Addendum No. 3

Bid / Request for Proposal Call No. T2024-220 Construction of the Fire station

This Addendum forms part of the Bid/Proposal Document.
(Question 1-95 had already been replied in Addendum 01 and 02)

MECHANICAL CONTROL SEQUENCES I

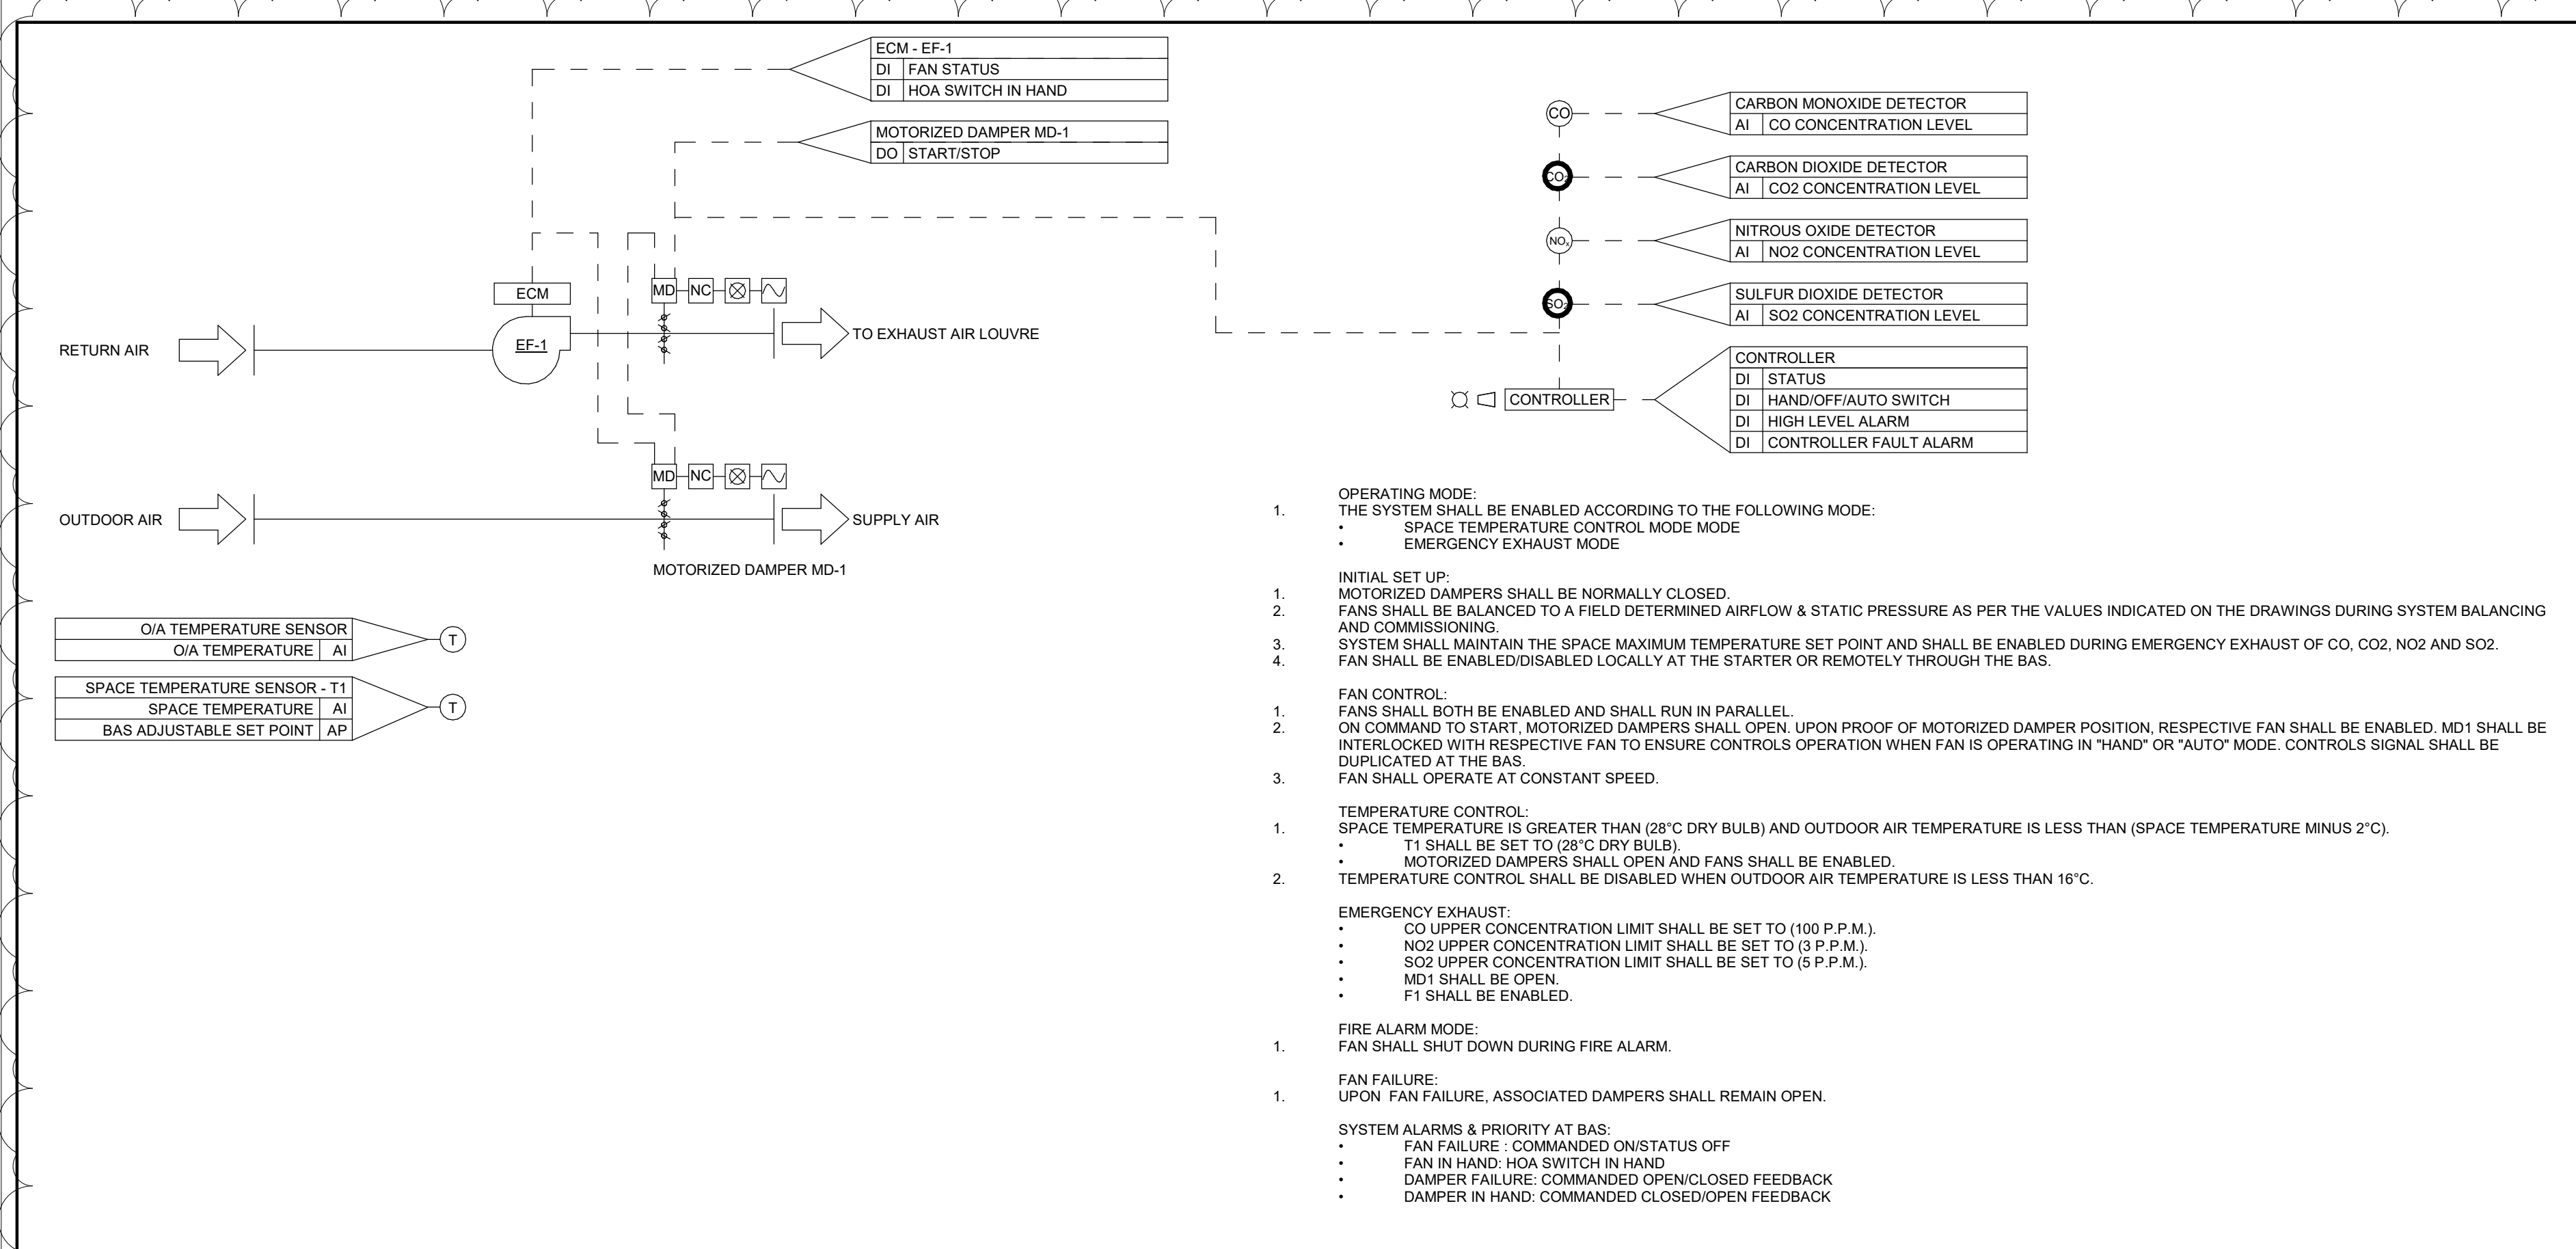
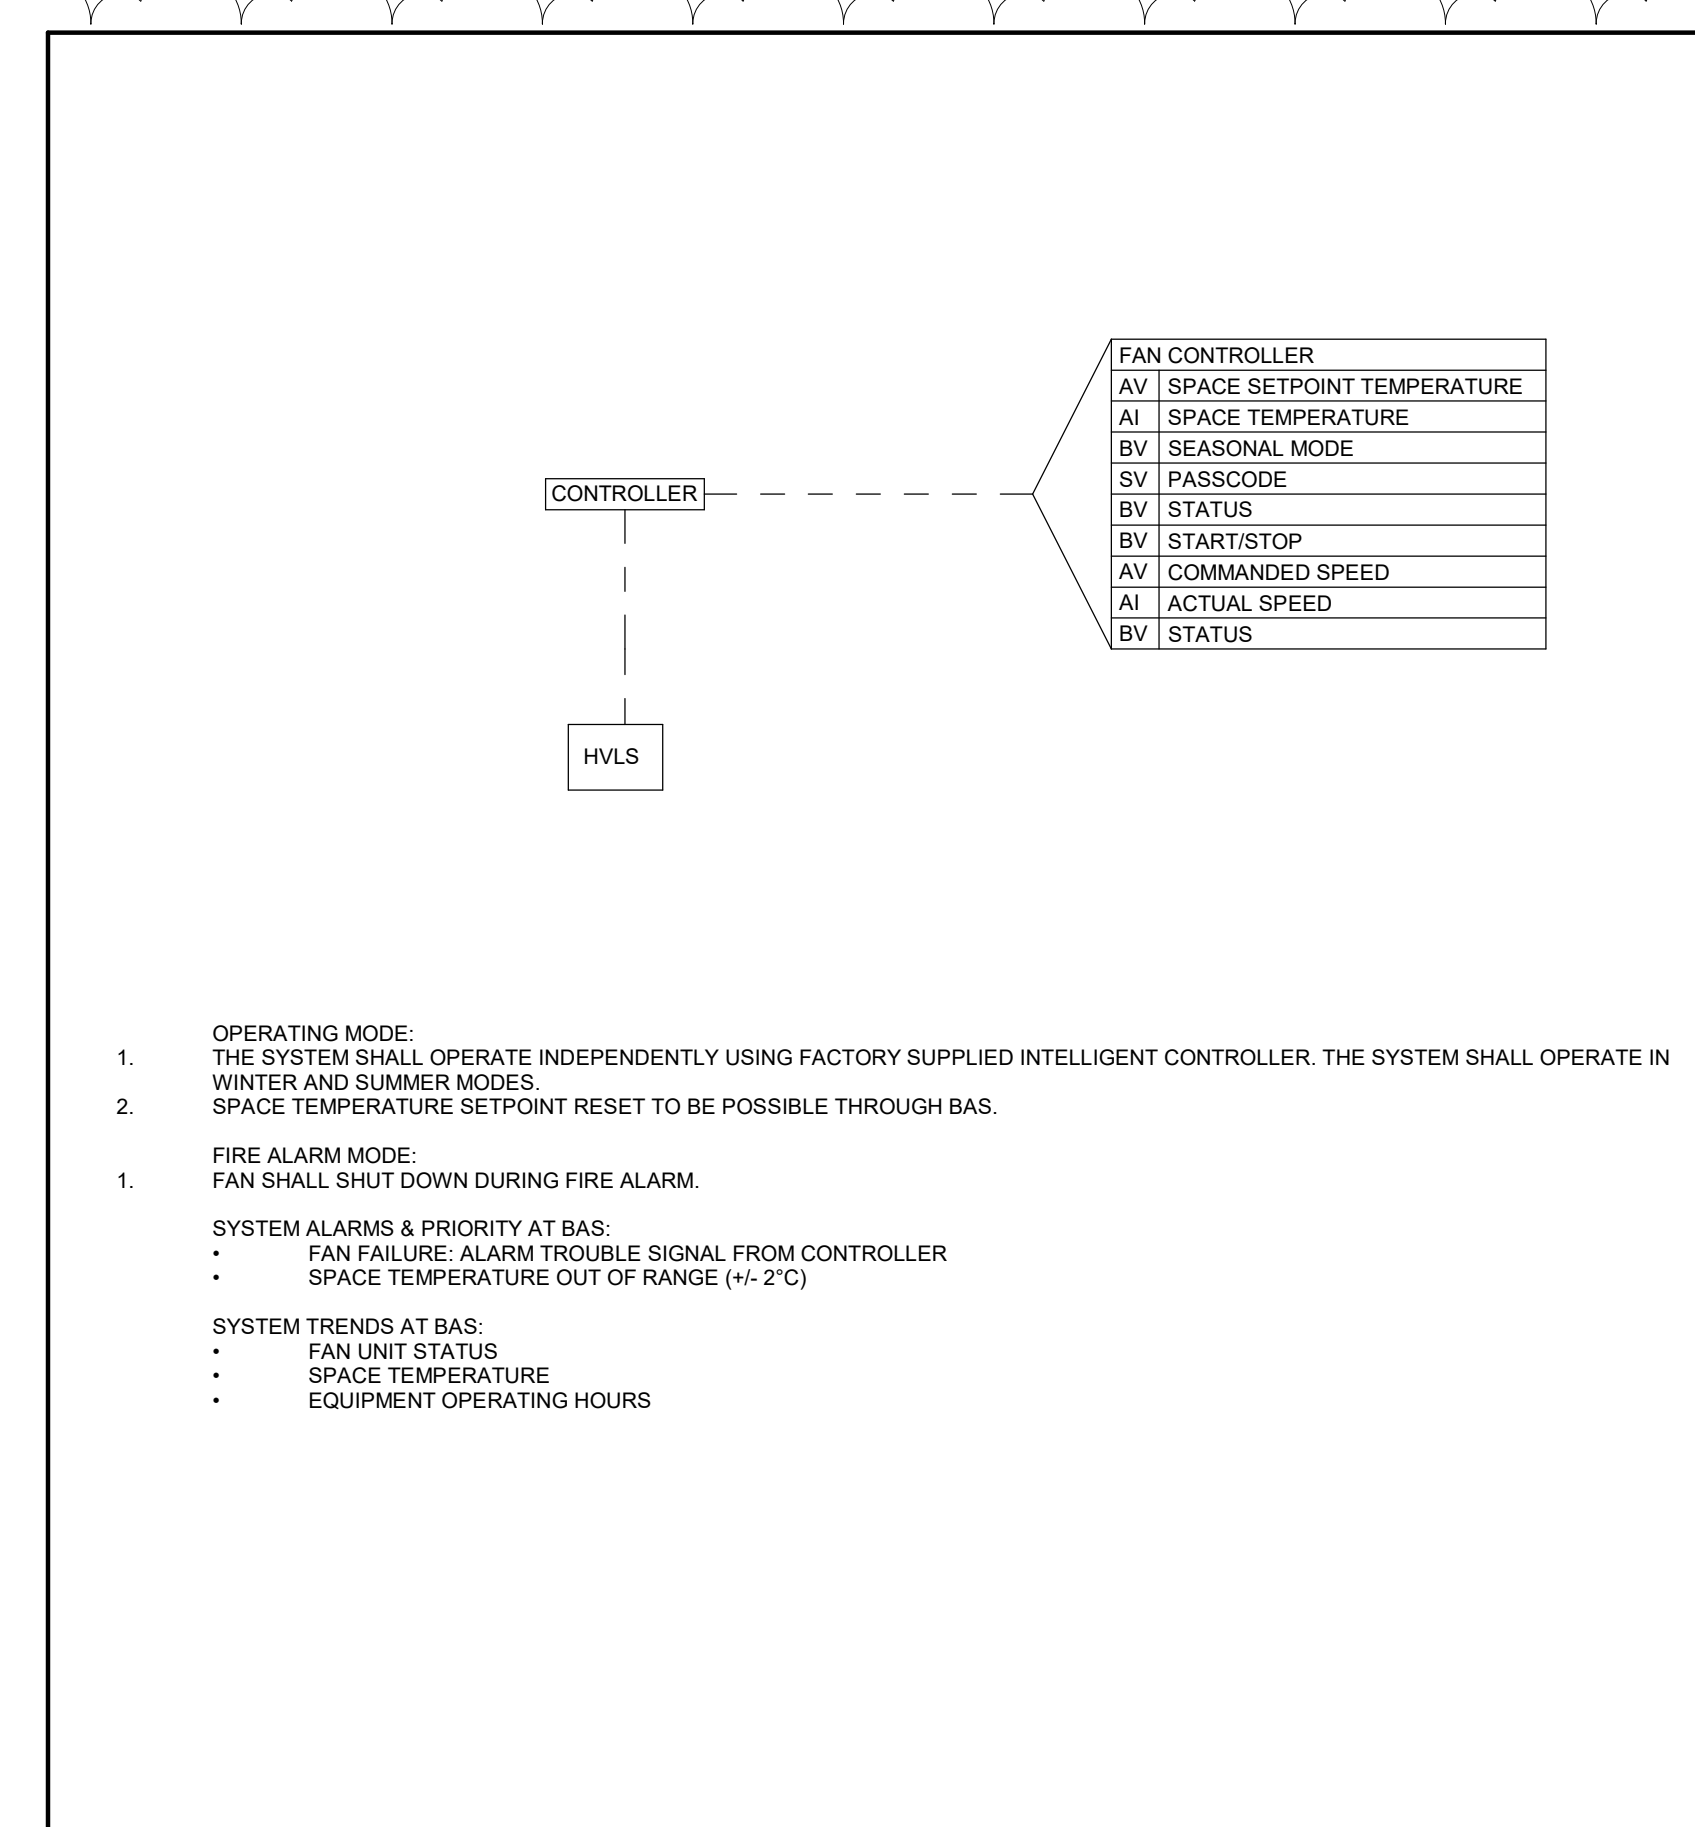
- .1 Drawing M-301 – LEVEL 01 PLAN - VENTILATION**
- i) Added tagging for exhaust tail pipe guide rail.
 - ii) Added symbol for SO2
- .2 Drawing M-751– MECHANICAL CONTROL SEQUENCES I**
- i) Updated apparatus bay fan control sequence
 - ii) Updated ceiling mounted destratification fan(HVLS) control sequence
- .3 Drawing M-753– MECHANICAL CONTROL SEQUENCES III**
- i) Added domestic hot water tank control sequence
- .4 Drawing M-754– MECHANICAL CONTROL SEQUENCES IV**
- i) Added VRF fan coil unit control sequence
 - ii) Added energy recovery ventilators control sequence
 - iii) Added desiccant dehumidifier control sequence
 - iv) Added kitchen exhaust fan control sequence
- .5 Drawing M-755– MECHANICAL CONTROL SEQUENCES V**
- i) Added Exhaust Fan (EF-2, EF-3, EF-4 & EF-6) control sequence
 - ii) Added DX fan coil unit control sequence
